MONTICELLO NUCLEAR GENERATING PLANT

Amendment No. 11  
License No. DPR-22

SAFETY EVALUATION BY THE OFFICE OF NUCLEAR REACTOR REGULATION

SUPPORTING AMENDMENT NO. 11 TO FACILITY OPERATING

FIGURE 1

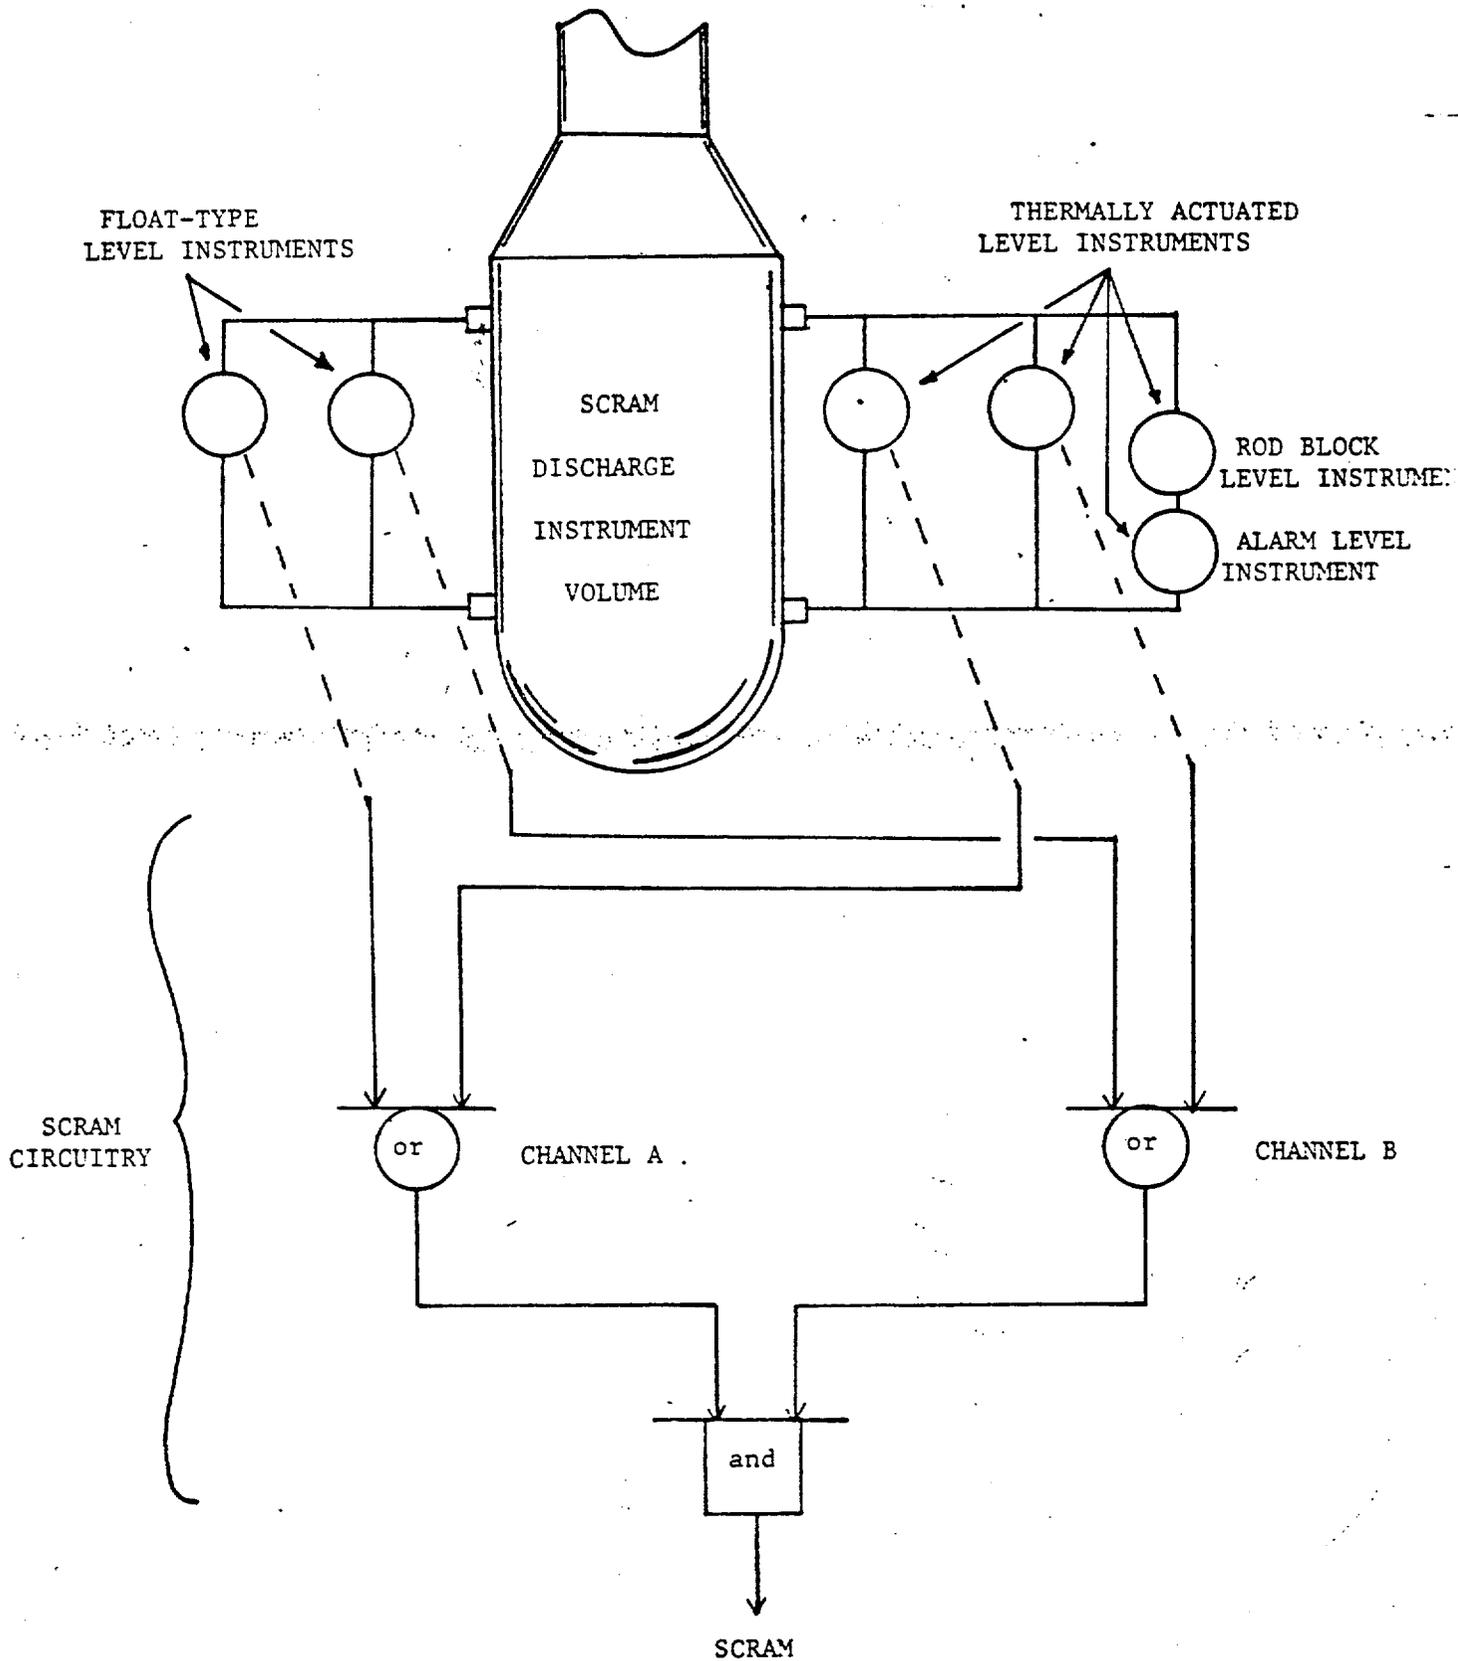
Each instrumented volume has two sets of instrument taps, providing two parallel hydraulic circuits. Scram level instruments in both hydraulic circuits assure that failure of a single instrument, or plugging of one instrument line will not prevent scram initiation. (See Figure 1.)
